<b>Product / Process Change Notification (PCN)</b>																																																							
<input checked="" type="checkbox"/> Major Change <input type="checkbox"/> Minor Change																																																							
<b>PCN Number:</b> PCN_RfKIHC_20241025  <b>Affected Series:</b> WE-KI HC 0603  <b>Affected Order Codes:</b> See table below  <b>PCN Date:</b> 2024-07-25  <b>Effective Date:</b> 2024-10-25	<b>Change Category:</b> <input type="checkbox"/> Equipment/Location <input type="checkbox"/> General Data <input type="checkbox"/> Material <input checked="" type="checkbox"/> Process <input checked="" type="checkbox"/> Product Design <input type="checkbox"/> Shipping / Packaging <input type="checkbox"/> Supplier <input type="checkbox"/> Software																																																						
<b>Contact:</b> Product Management  <b>Phone:</b> +49 (0) 7942 - 945 5001  <b>Fax:</b> +49 (0) 7942 - 945 5179  <b>E-Mail:</b> pcn.eisos@we-online.com	<b>Datasheet Change:</b> <input checked="" type="checkbox"/> Yes <input type="checkbox"/> No  <b>Attachment:</b> <input type="checkbox"/> Yes <input checked="" type="checkbox"/> No

Datasheet before change	Datasheet after change

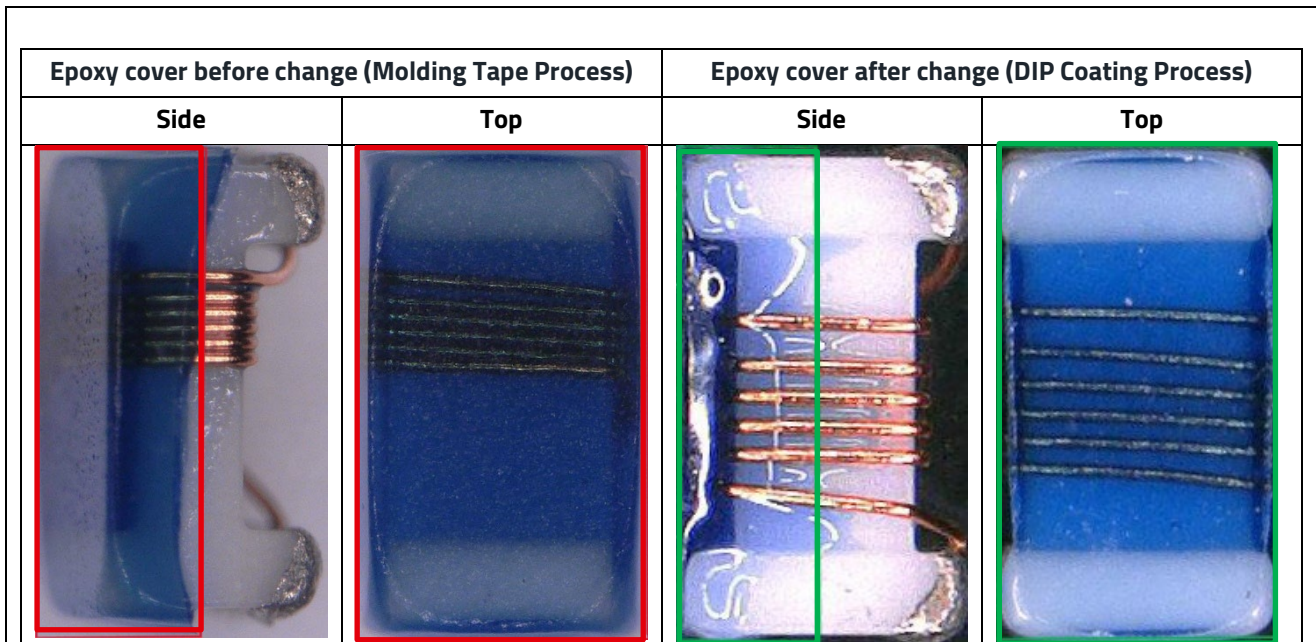
The previous molding tape coating process will be changed by a DIP coating process to increase our production line capacity.

The change in the coating process will affect the dimensions of the product cover, resulting in an insignificant change in the overall product dimensions – for more information see picture below.

The purpose of this epoxy cover is only to allow the Pick & Place process. This change has no influence in the electrical parameters of the product.

Dimensions before change		Dimensions after change	
(Unit: mm)		(Unit: mm)	
L	1.70 ± 0.2	L	1.60 ± 0.2
W	1.10 ± 0.2	W	1.0 ± 0.2
H	0.90 ± 0.2	H	0.80 ± 0.2
